## Placement of Headed Shear Stud Reinforcement

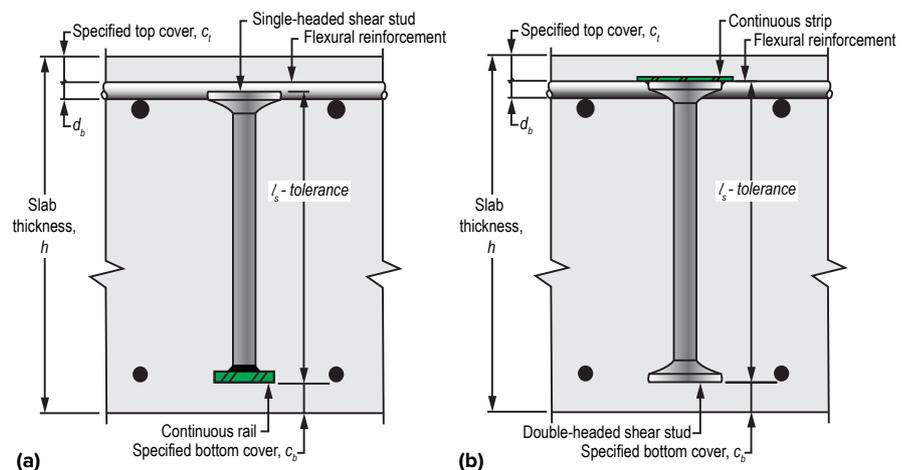
**Q.** We specified headed shear stud reinforcement per Fig. 1(a) at slab-column connections. However, the concrete contractor submitted placing drawings with shear stud reinforcement shown in an “upside-down” configuration per Fig. 1(b). Does this submittal meet the requirements of ACI 318-19?

**A.** Requirements for the overall height of a shear stud assembly are provided in Section 8.7.7.1.1 of ACI 318-19, and they are illustrated in Commentary Fig. R20.5.1.3.6. Paraphrasing these requirements, the overall height of the stud assembly must be **at least** the slab thickness minus the sum of the top cover, the bottom cover, and a placement tolerance of  $d_b/2$ , where  $d_b$  is the diameter of the flexural tension reinforcement.

Similarly, Fig. 6 in ACI 421.1R-20<sup>2</sup> illustrates the overall height of the stud assembly as  $l_s - \text{tolerance}$ . In this illustration,  $l_s = h - c_t - c_b$ , where  $h$  is the thickness of the slab,  $c_t$  is the concrete cover on the top flexural reinforcement, and  $c_b$  is the concrete cover on the base rail; and  $\text{tolerance} \leq d_b/2$ . That notation is also used in Fig. 1.

Thus, ACI 318-19 permits headed shear stud installations comprising stud assemblies with double-headed studs held by a continuous strip resting on top bars (or simply individual double-headed studs wired in place at the specified spacing). Because Fig. R20.5.1.3.6 is included in the Commentary of ACI 318-19, it serves merely as an example and does not limit assemblies to only the type that is illustrated. The final selection will be made by the concrete contractor based on labor, material, and schedule costs.

In summary, the so-called “upside-down” shear stud reinforcement assembly submitted by your contractor (Fig. 1(b)) meets ACI 318-19

requirements and your specification.
